CITY OF SEQUIM DEPARTMENT OF COMMUNITY DEVELOPMENT

STAFF REPORT AND DIRECTOR'S DECISION

"Jamestown S'Klallam Tribe Outpatient Clinic" Design Review Application

File No. CDR 20-001

ILLUSTRATION 3

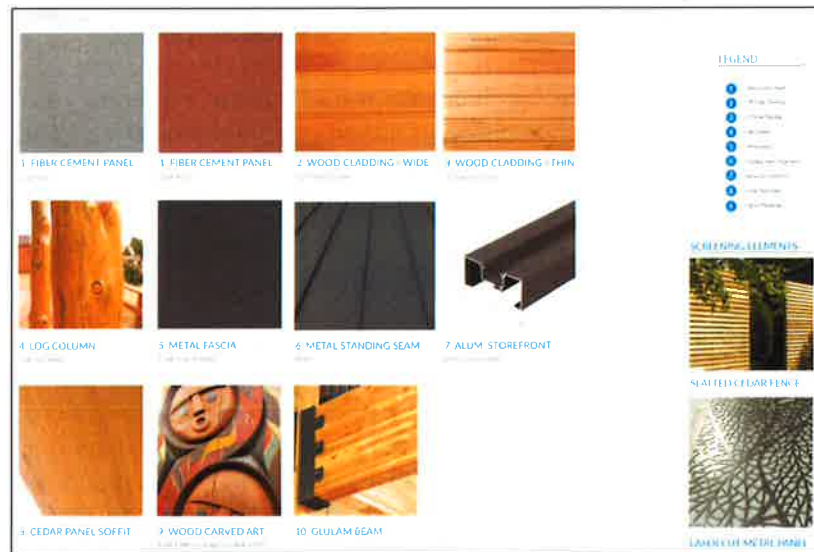
Staff comment: The project proponent has graphically submitted a proposed color palette along with the proposed materials for their project on page 4 of the plan set. The palette includes all the materials and colors proposed for the project. As shown on the plan set pages 5 and 6, there are no more than three distinct colors used on the proposed building (stained cedar, dark red, and dark gray). All colors will have low reflectivity and blend well with the surrounding environment (See Illustrations 1 and 2 above).

ILLUSTRATION 4-SITE PLAN WITH PARKING LOT LAYOUT

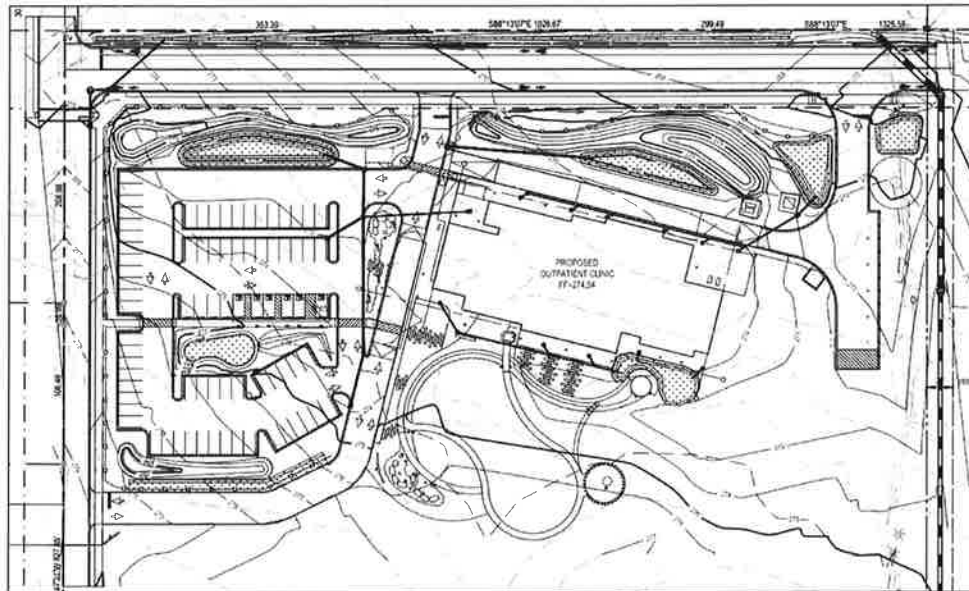
Staff comment: The design for the project’s off-street parking would minimize visual impact to streets and adjacent spaces/properties by providing landscaping and creative low impact stormwater management techniques. Parking areas are designed to have safe and efficient ingress and egress for vehicles and have been configured and designed to reduce the overall mass of paved surfaces. The off-street parking for 96 vehicles has been visually and functionally divided into smaller parking areas throughout the parking lot. Parking is setback no less than ten feet from abutting properties and rights-of-way with landscape buffers and no off-street parking is located forward of the front façade of the proposed building.

Therefore, the proposal satisfies the standards for parking lot design and orientation.
